SAFETY RECALL

Date	Number	Release	Page
06.2026	RVXX2605	01	1 (5)

EPM X3 Connector Exposed VN (4)

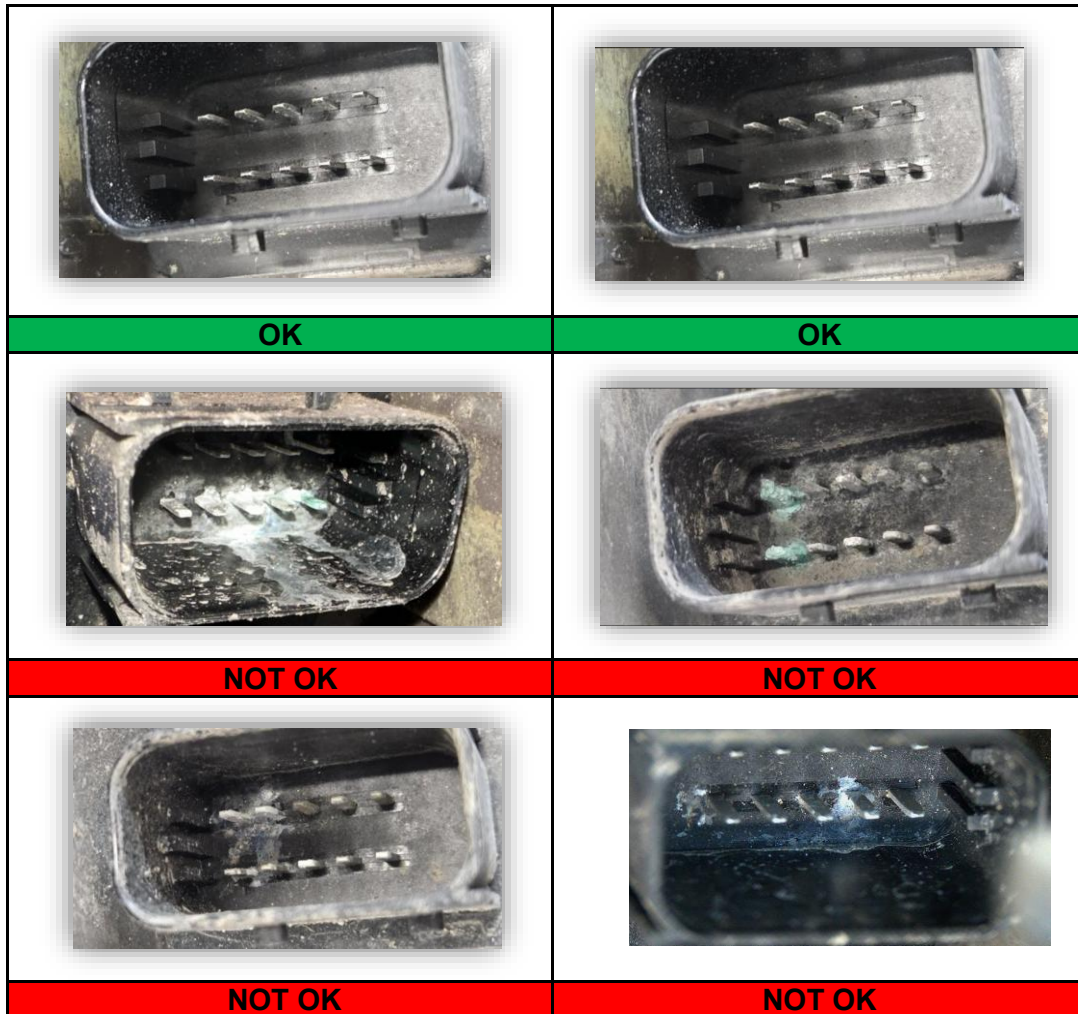
3. Locate the EPM on the rear of the truck. (Driver's side frame rail above the axle).
4. Locate the X3 connector on the EPM and remove the protective cover.

5. Inspect the X3 cavity for any corrosion.
 - a. If corrosion is found in the X3 cavity, continue to **Step 6**.
 - b. If the X3 cavity is free of corrosion, continue to **Step 7**.

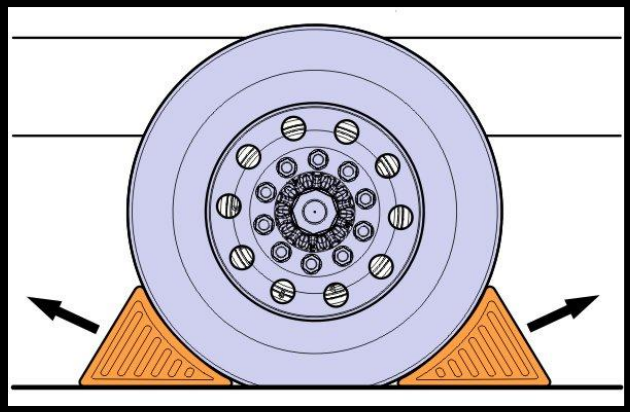
6. Replace the EPM with a new one following Impact operation **5600-03-02-02 Modulator, Rear, Replacement**. Before installing the EPM add the protective cap **995115** to the X3 cavity.
7. Ensure cavity is clean and dry.
8. Install a protective cap **995115** on the X3 cavity.
9. Install and latch the protective cover.
